HIGHWAYS DEPARTMENT

EIA for Salisbury Road Underpass and Associated Road Improvement Works including Middle Road Circulation System

Final EIA Report

June 1999

Maunsell		TITLE		Salisbury Road Underpass and Associated Works		MAUNSELL ENVIRONMENTAL MANAGEMENT CONSULTANTS LTD	
		PROJECT NO.	C440	DATE	Mar. 1999	DRAWING NO.	Figure 2.1
		DESIGNED	Fanny Lau

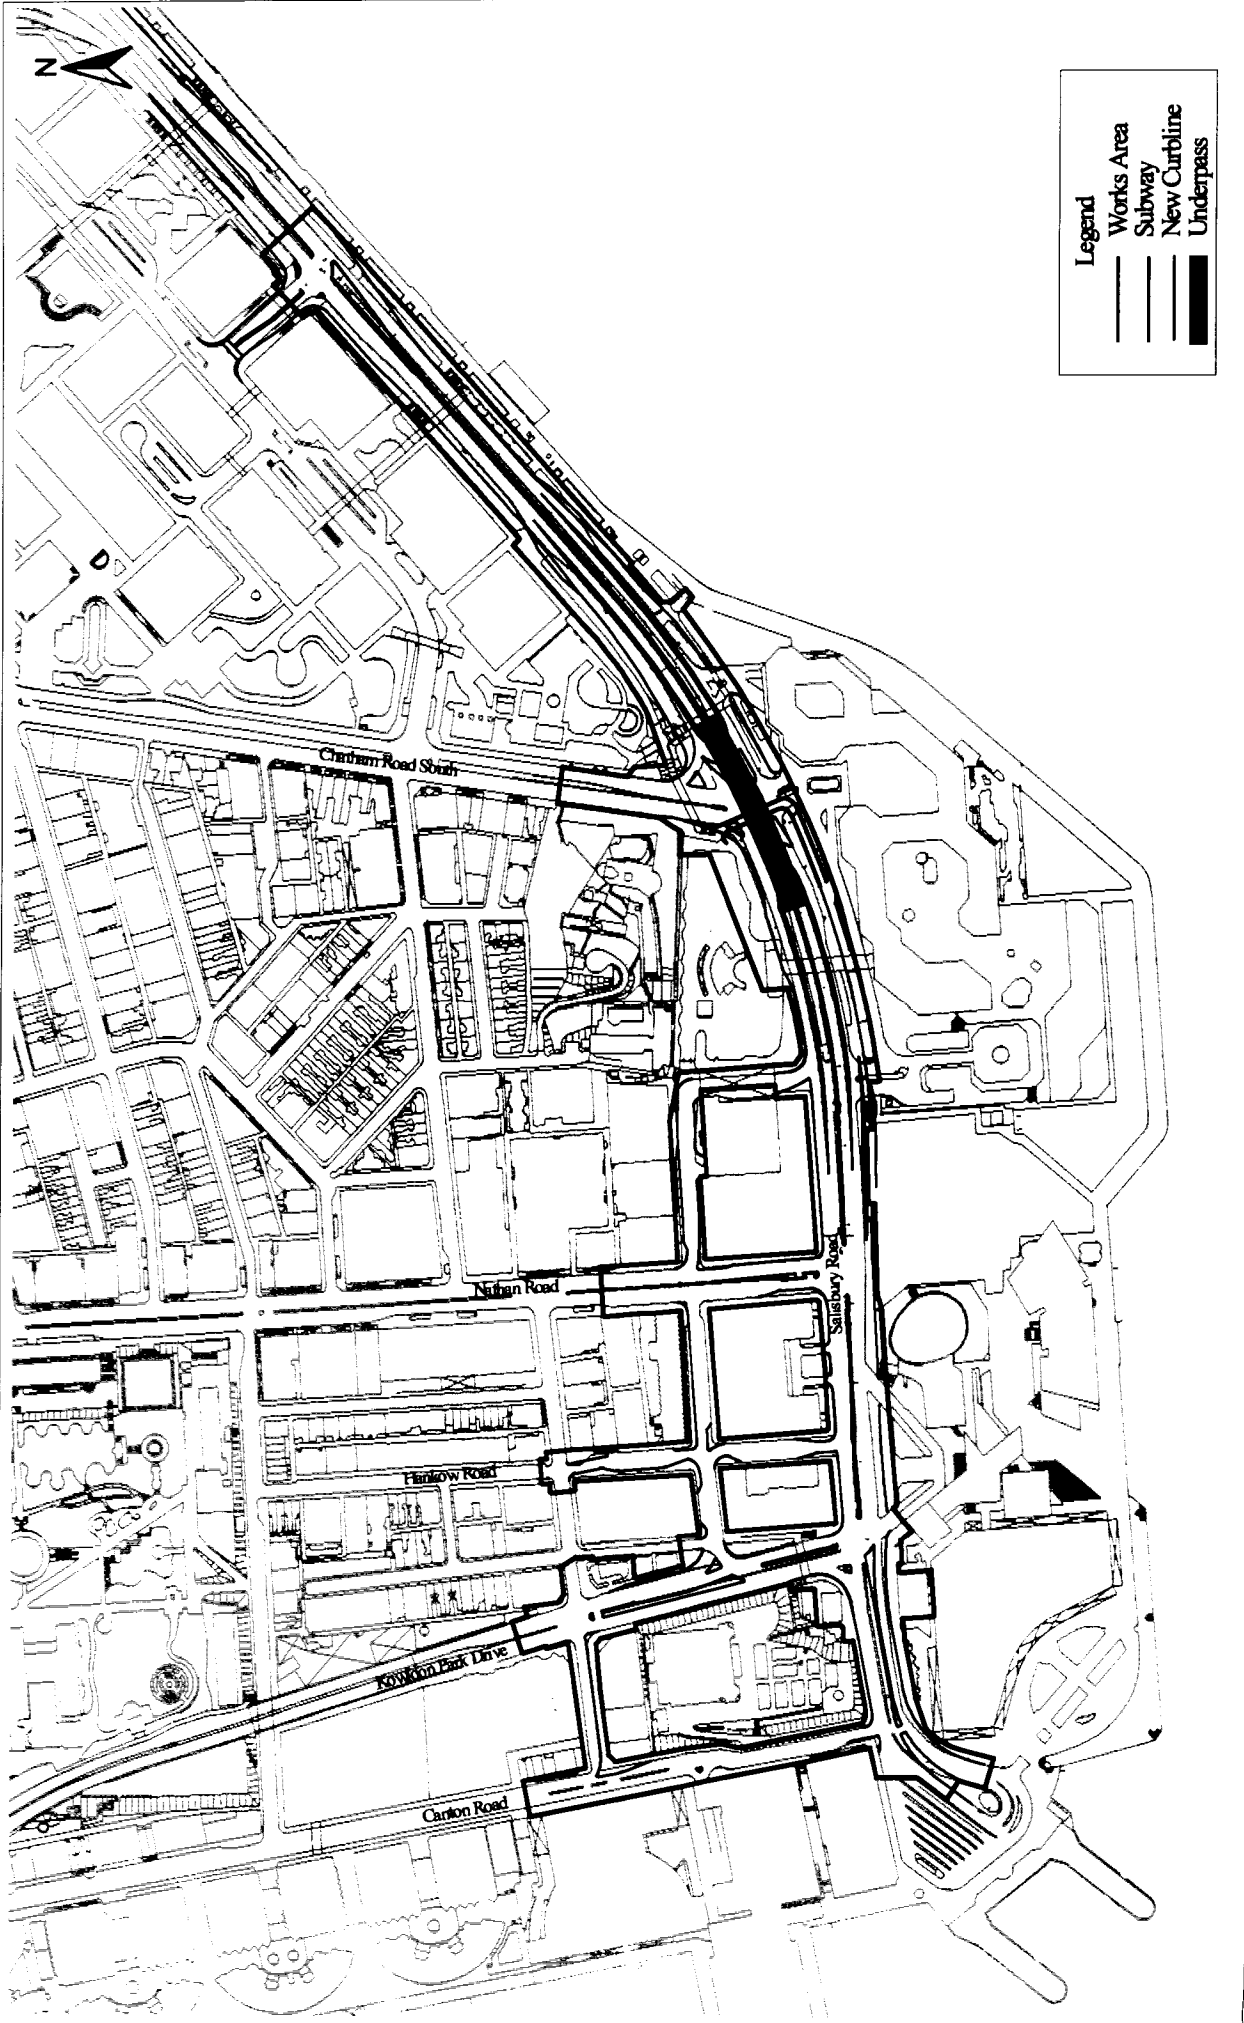
(f)	<p>item D in Appendix A “Responses to Comments Received”: Please amend the typo from “SO” to “SO₂”.</p>	<p>Noted. The word would be amended.</p>
(g)	<p><u>Figure 2.1 “Salisbury Road Underpass and Associated Works”:</u> As discussed, to avoid confusing the ACE or the public, please add the major road and street names on this figure.</p>	<p>Noted. The major road and street names would be added in figure 2.1.</p>

PROJECT NO		C440	
DATE		Mar 1999	
DESIGNED / CHECKED	Anna Chung		DRAWING NO
		Figure 2.2A

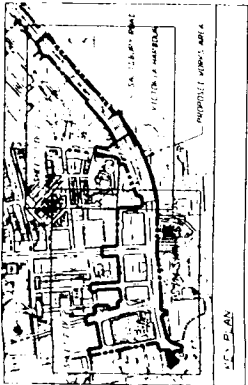
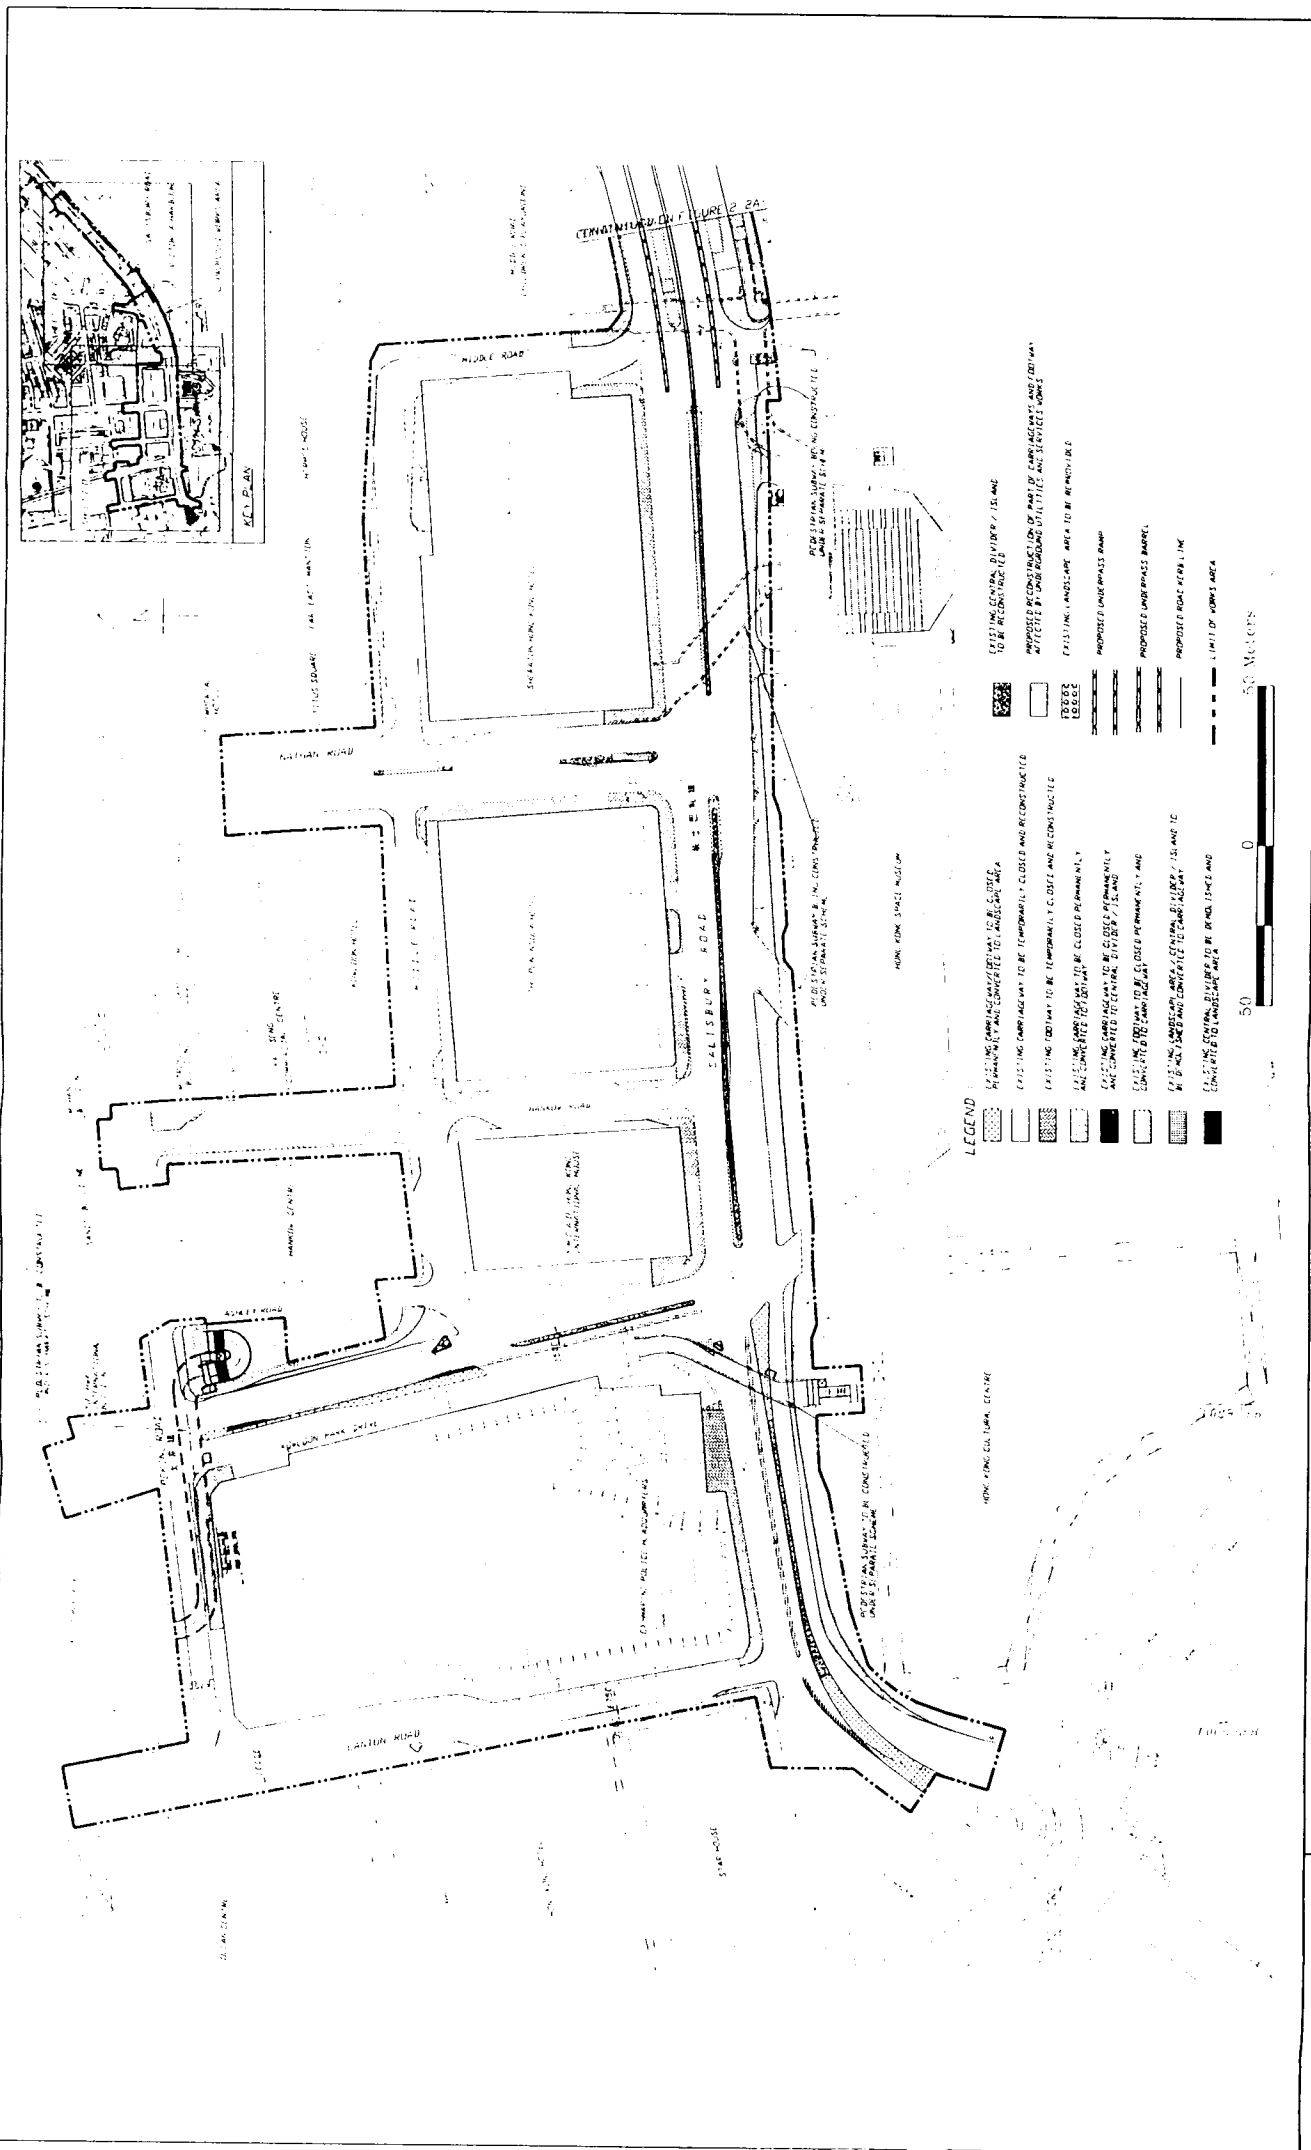
(b)	<p><u>Figures 2.2A & 2.2B</u> The proposed landscaped area as identified in the figures appear to have some discrepancies with the gazettal drawings of the same project which I have recently received. The Consultants is requested to clarify and amend the figures accordingly.</p>	<p>Noted. Please find attached revised Figure 2.2 A and 2.2 B for your information.</p>

(c)	<p><u>Para. 9.4, bullet one</u> Please add "CDA" zone into the text in order to be consistent with the conclusion at para.11.6.</p>	Noted.
(d)	<p><u>Figure 2.2A & B</u> Some discrepancies are still noted between the figures and the gazettal drawings. According to the gazettal drawing, the traffic island at the junction of Chatham Road and Salisbury Road is a landscaped area, not forming part of road as shown on figure 2.2A. Moreover, a number of other discrepancies regarding the width and alignment of the pavement /road as shown on the figures are different from the gazettal drawings.</p>	Noted. Figure 2.2A & B would be amended.

MAUNSELL ENVIRONMENTAL MANAGEMENT CONSULTANTS LTD			
PROJECT NO	C440	DATE	June 1999
DESIGNER	Anna Chung	DRAWING NO	Figure 9.1(a)

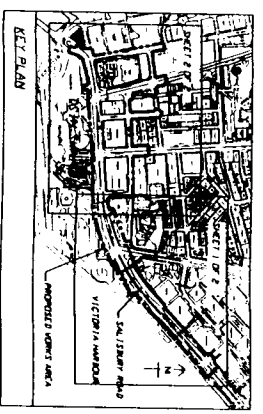
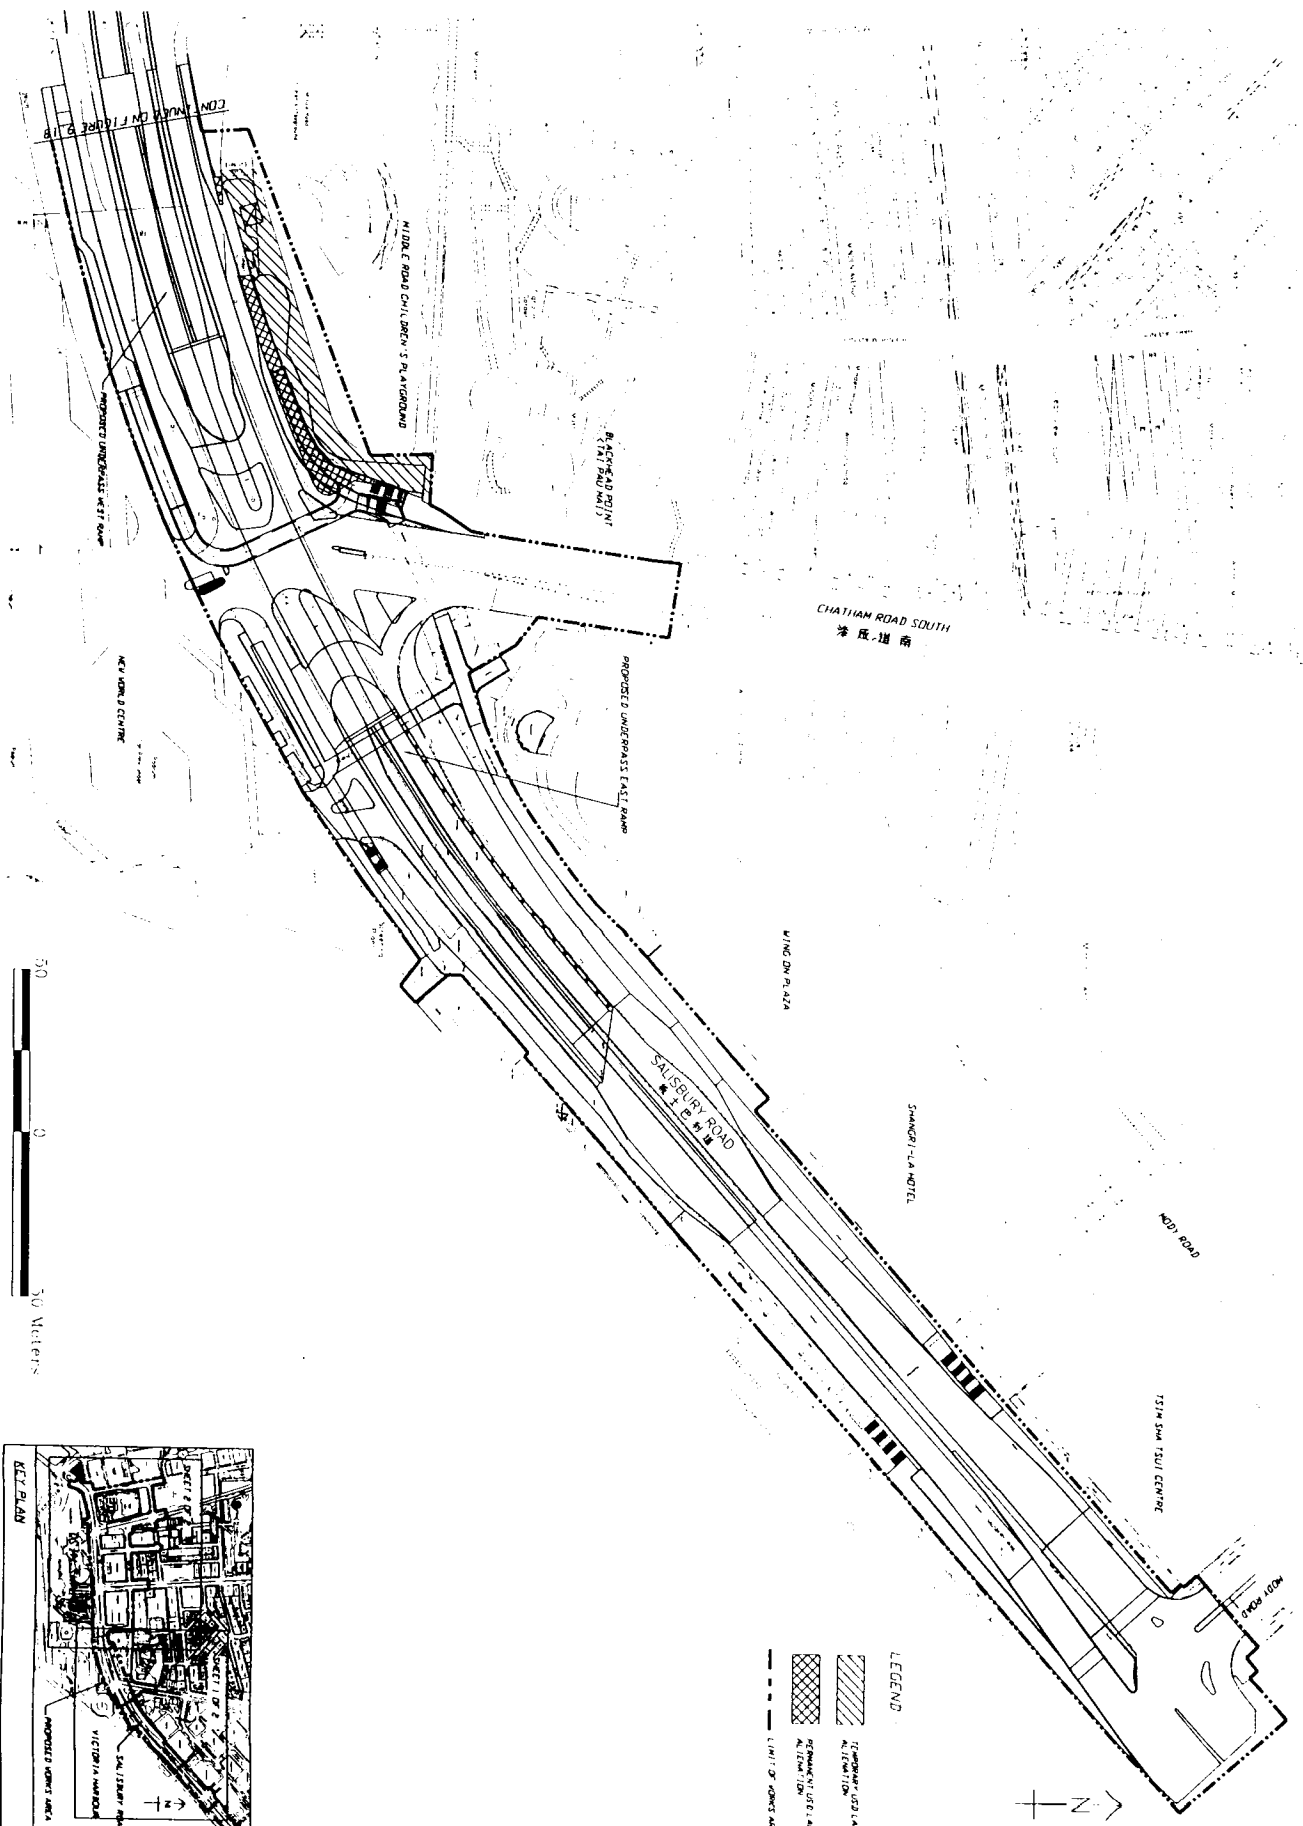
(i)		
(ii)	<p>The land requirement plan as shown on Figure 9.1(a) & (b) are not attached for reference. Presumably, the extent of land requirement is the same as that shown on Figures 10.1(a) & (b) of the previous draft EIA report (November 1998). As such, you are advised to seek the agreement from Director of Urban Services since the project requires the temporary occupation of some open spaces such as the Middle Road Children's Playground and the Sitting-out are in Peking Road.</p>	Noted.
